PROJECT : JR8

Size	Document Number	Rev
	Audio MIC/LINE-OUT	3A
Date:	Friday, December 03, 2010	Sheet 2 of 4

Size	Document Number	Rev
	USB	3A
Date:	Friday, December 03, 2010	Sheet 3 of 4

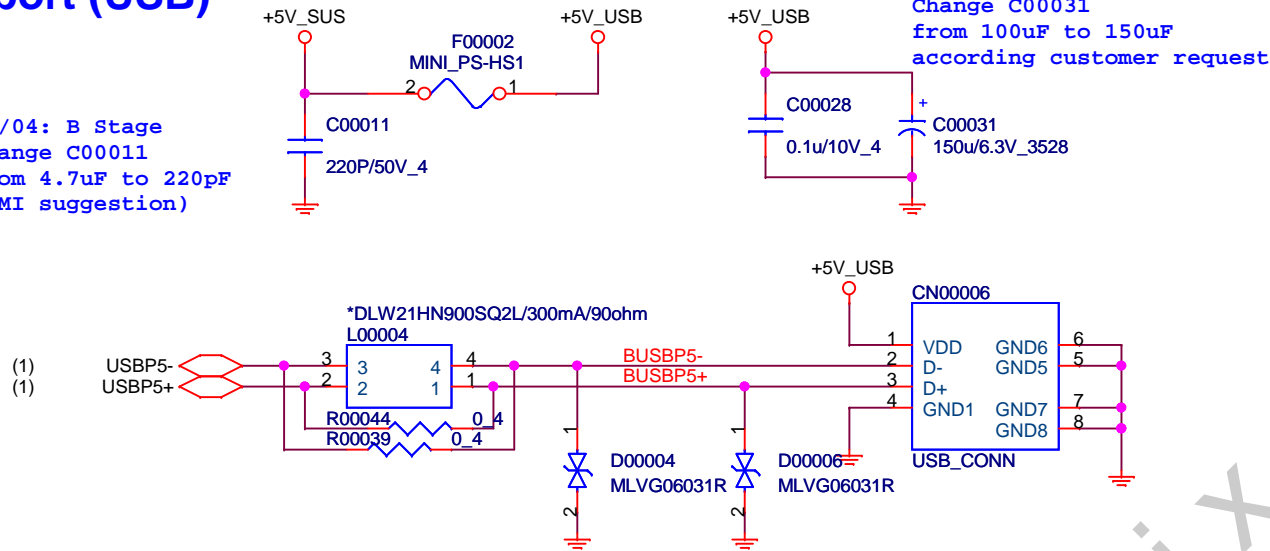
10/04: B Stage
Change C00011
from 4.7uF to 220pF
(EMI suggestion)

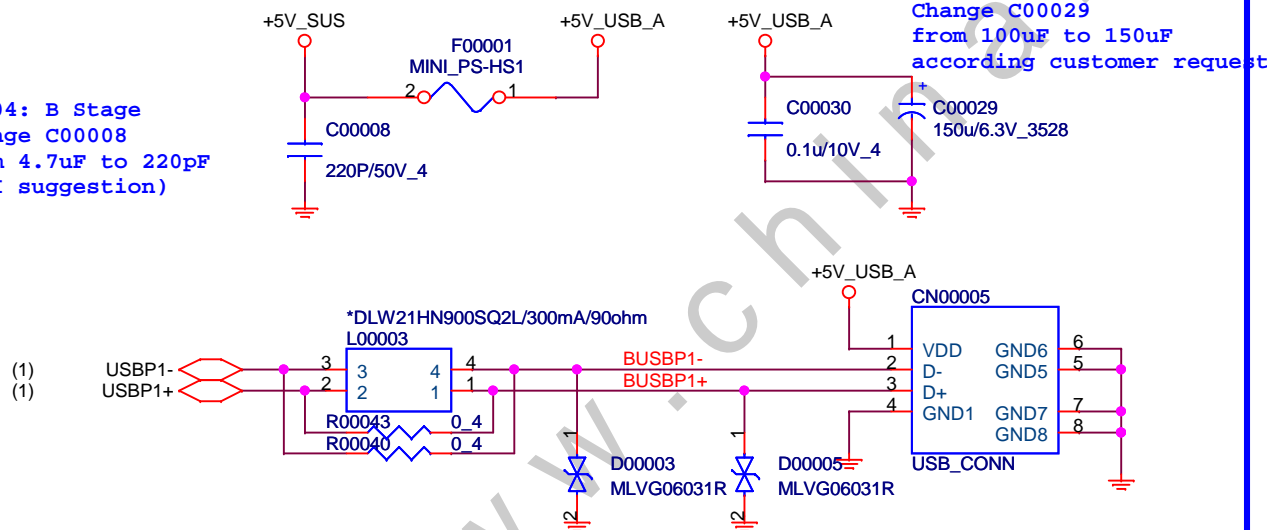
10/04: B Stage
Change C00008
from 4.7uF to 220pF
(EMI suggestion)
